SUBJECT: Amendment #17A Contract No. #71754-22 Bid #CDB-0132-21
J. B. Coxwell Contracting, Inc.
Design Build Services: Fire Station #19 Driveway Repairs and ADA Parking Improvements

Re: Fee Proposal for Fire Station #19 Driveway Repairs & ADA Parking Improvements
Design-Build Construction Delivery for City of Jacksonville
City Contract No. 71754-22

FIRE STATION # 19 DRIVEWAY REPAIRS & ADA PARKING IMPROVEMENTS
1072 ROGERO ROAD, JACKSONVILLE, FL 32211
(RE #: 141517-0100)

DESIGN CRITERIA PACKAGE

FIGURE 5

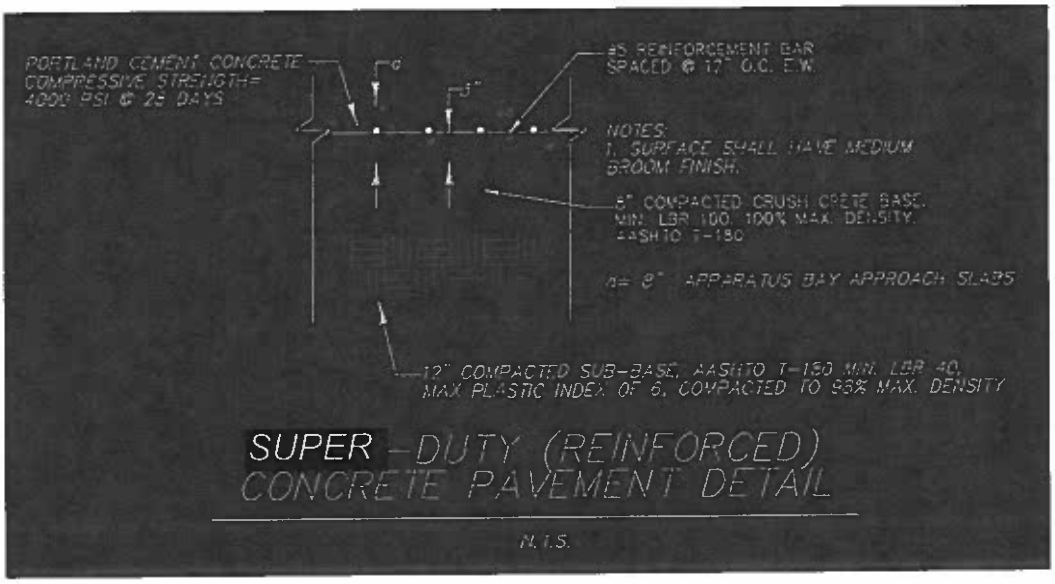
- Remove existing concrete strip in front of apparatus bay (depicted in Figure 3).
- Remove existing asphalt driveway from concrete strip to asphalt seam approximately 24 feet from Rogero Road west EOP (highlighted in Figure 4).
- Replace front driveway in all removal areas, ensuring the new driveway meets the following specifications (depicted in Figures 5 & 6 below), at a minimum:

SHEET NO. C2.0

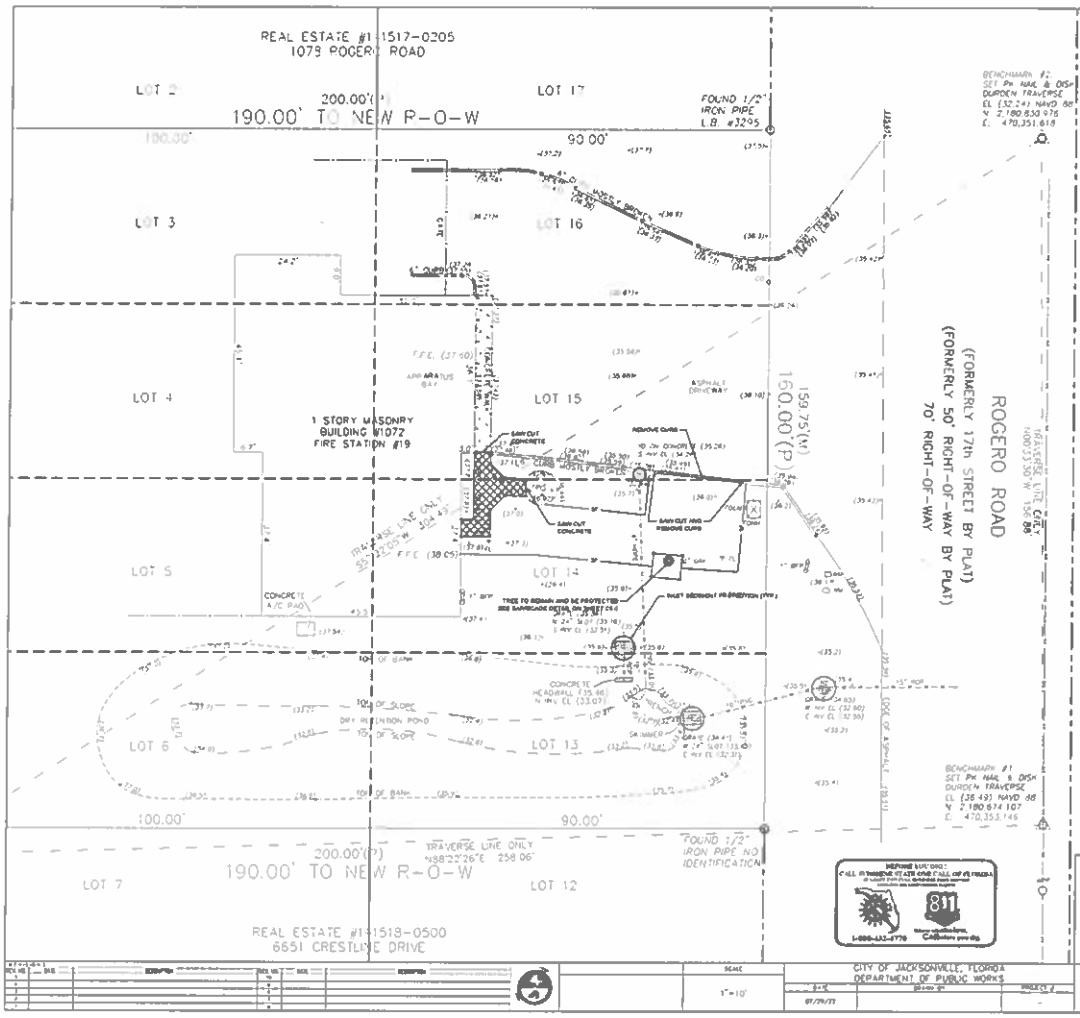
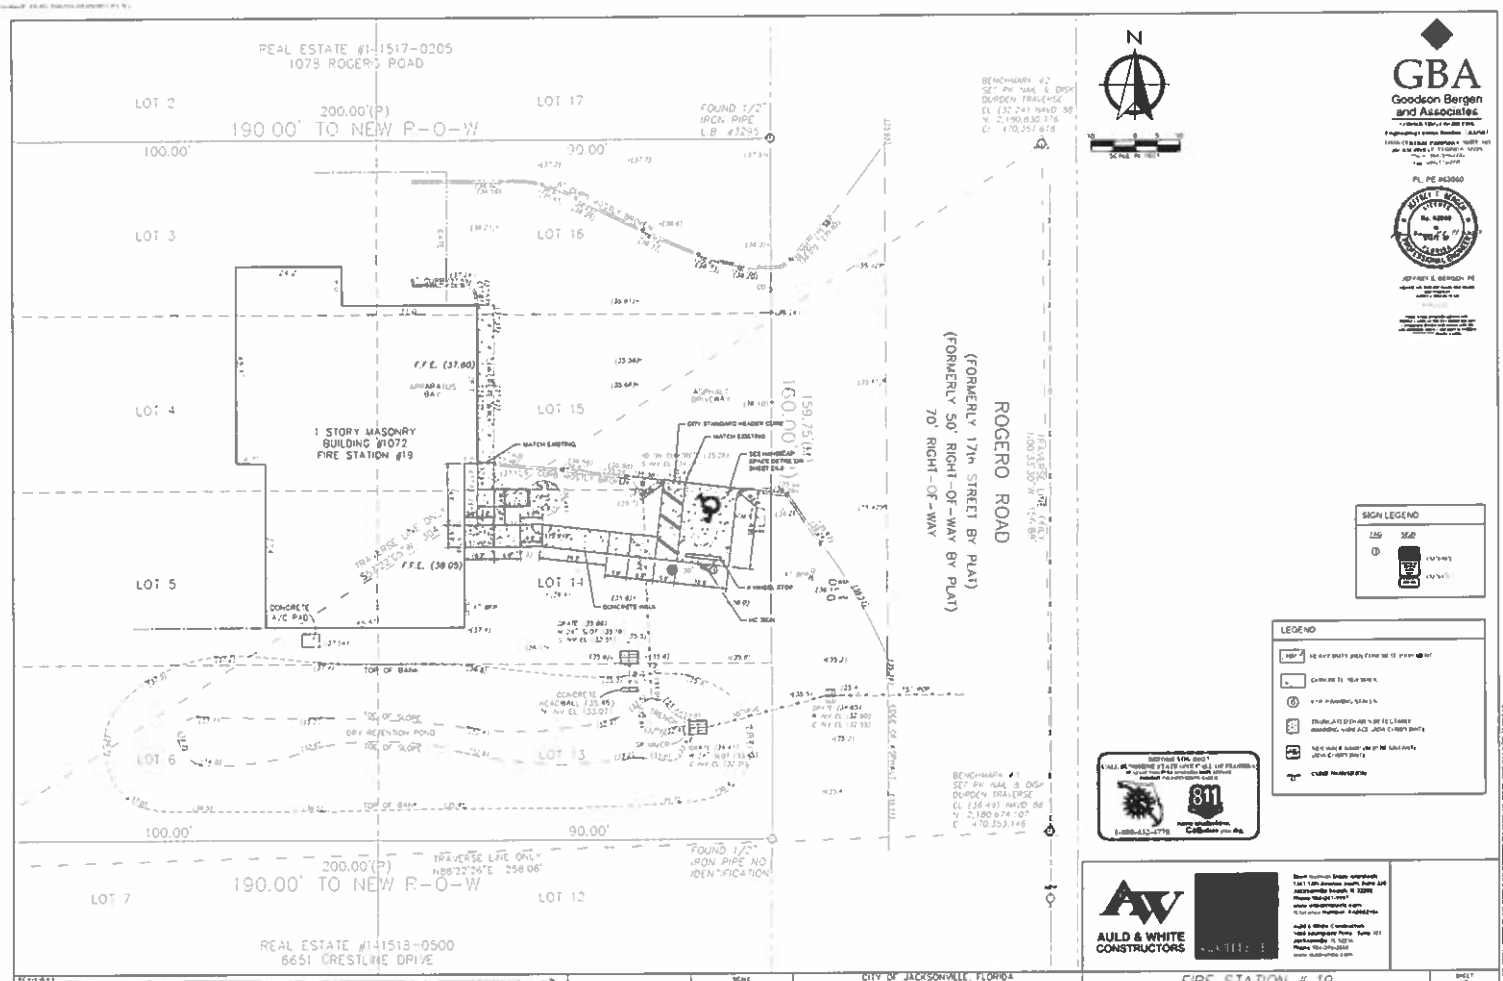
1)Tree Protection (Sec. 656.1207):
a.The Demolition and Landscape plans show conflicting information regarding the existing oak. Please revise. Also, the existing oak appears to be an exceptional specimen (1:1 mitigation) laurel oak.
b.Could the accessible parking space be proposed closer to the entrance and flag pole, therefore preventing the removal of the existing oak?

APPENDIX C - New Proposed Location of ADA Parking Improvements

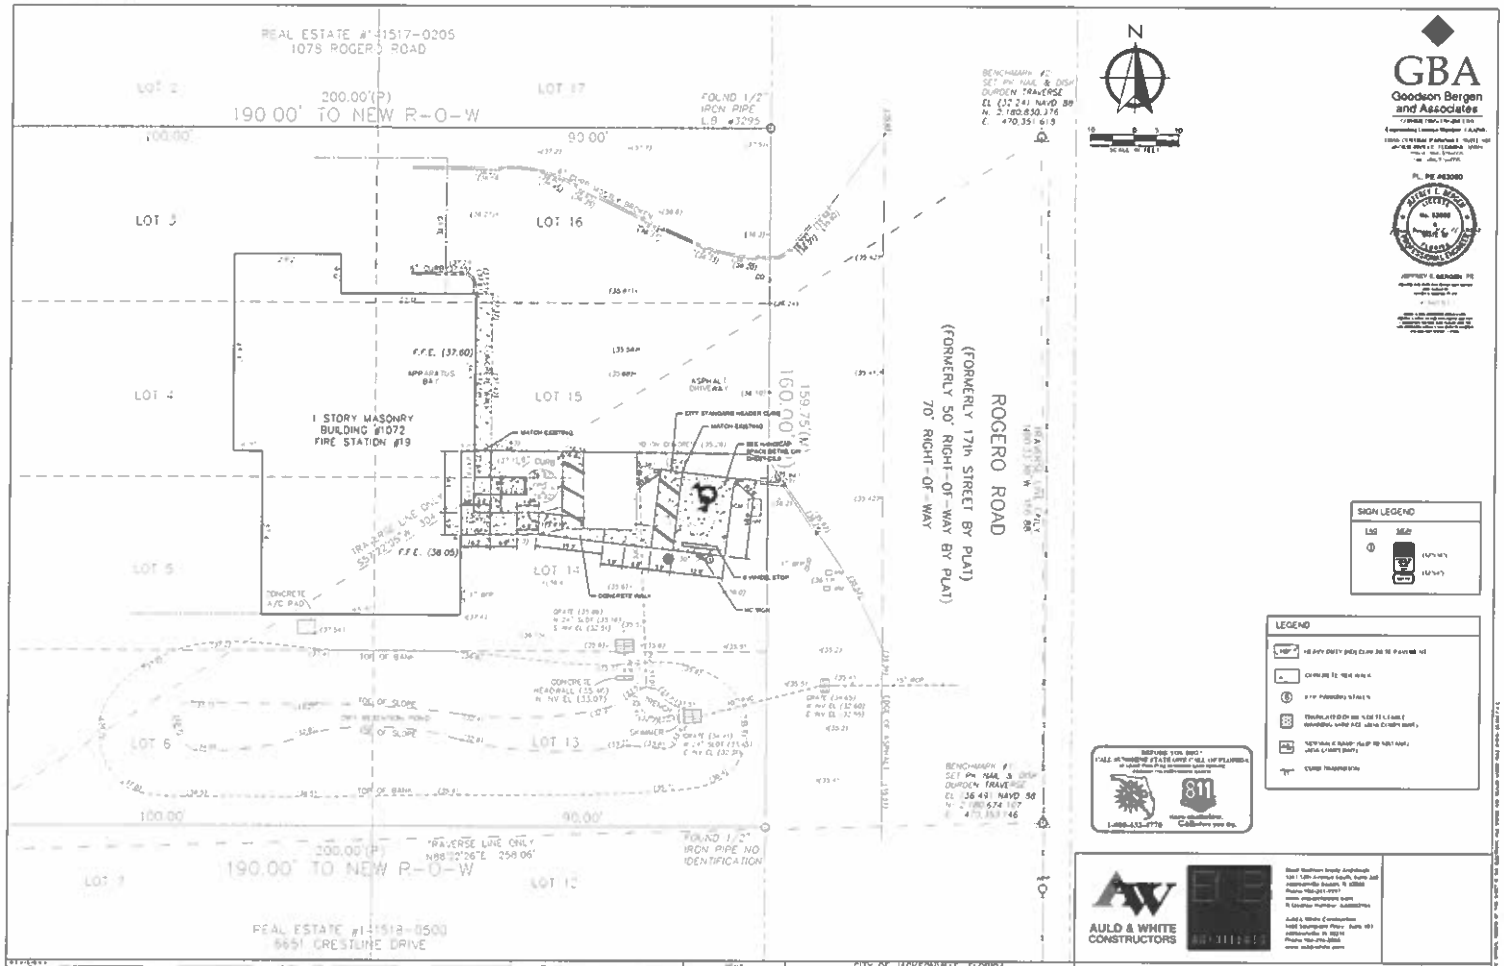
- Mesh with the DBF's Front Driveway plans, so the parking space will match the elevation and grade of the new driveway once constructed.
  - Avoid impacts to utilities, the 30" oak tree south of the Front Driveway, and the Fire Station flag pole. Where impacts are unavoidable, they shall be mitigated and minimized as best as possible.
